24 July 2025

Foodstuffs – Hearing 14 Presentation

MUZ-S5 and MUZ-S6 – Pedestrian Frontages and Verandahs

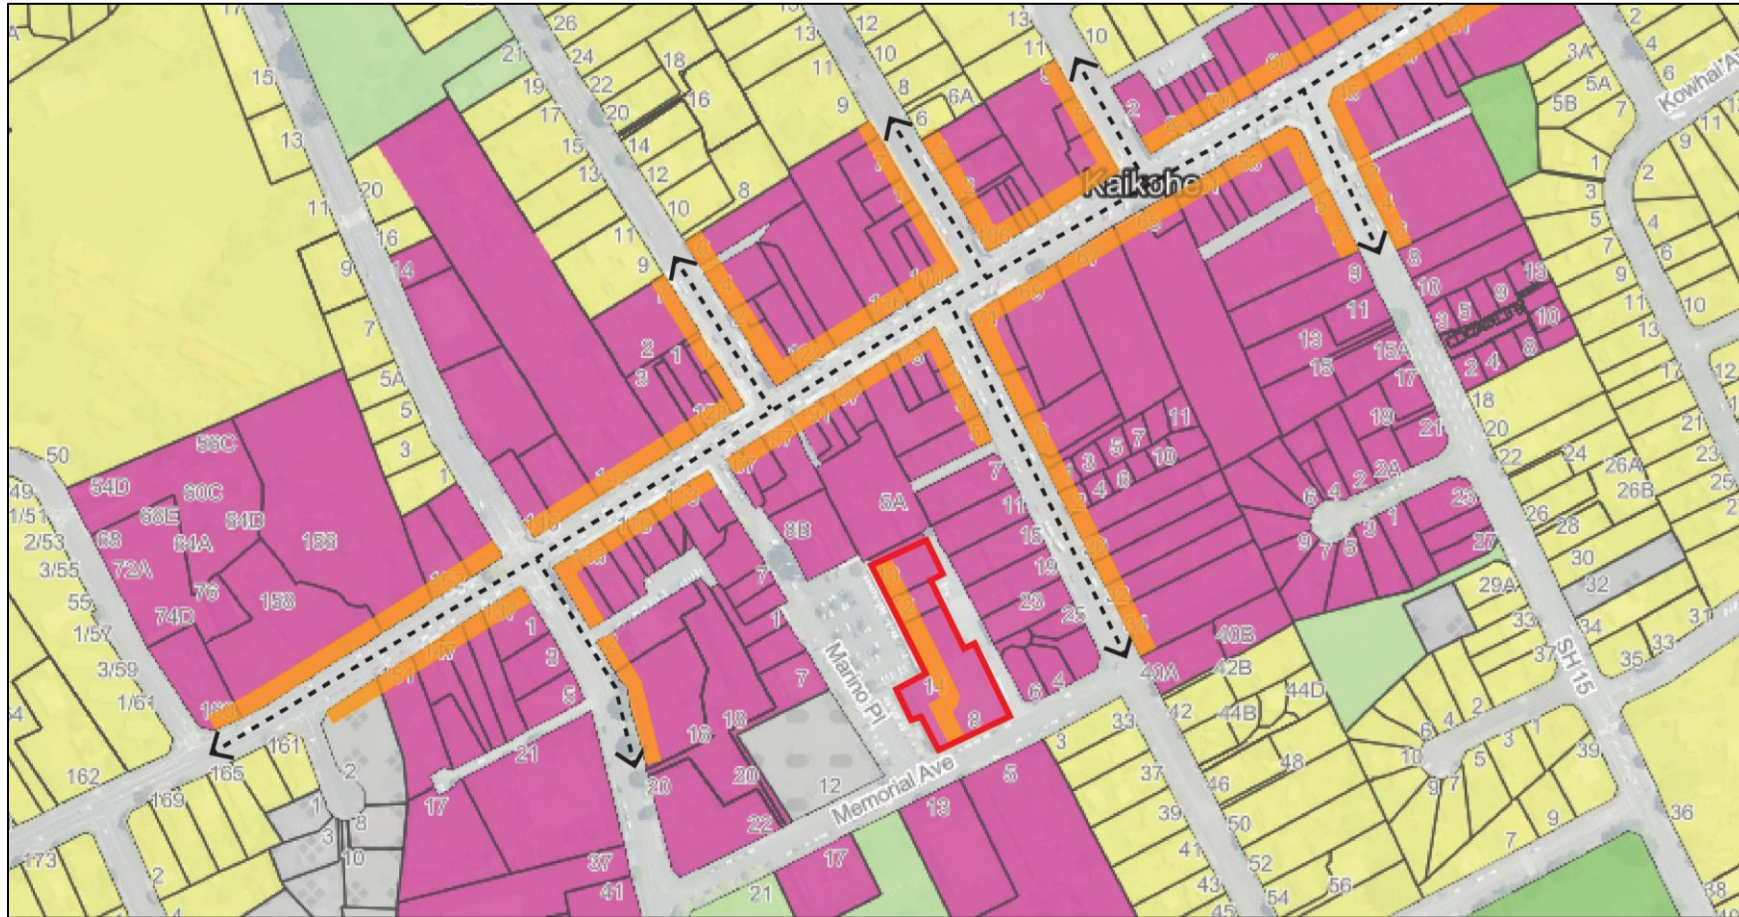
- Foodstuffs sought an exemption for supermarkets from the pedestrian frontage and verandah requirement.
- The Reporting Officer rejected exemptions for supermarkets, citing potential impacts on streetscape and adequacy of the restricted discretionary process to manage these effects.
- These standards have been reviewed from an urban design perspective, specifically in relation to Foodstuffs existing operations. In particular, New World Kaikohe (10 – 12 Marino Place, and 8 – 10 Memorial Avenue).

- Accept retaining the general recommendation of the Reporting Officer to retain the pedestrian frontage and verandah provisions.
- The Pedestrian Frontage Overlay at 8-10 Memorial Avenue and 10-12 Marino Place, Kaikohe, should be deleted based on urban design recommendation.

Delete the pedestrian frontage overlay as it applies to the New World Kaikohe store in the location outlined in red below.
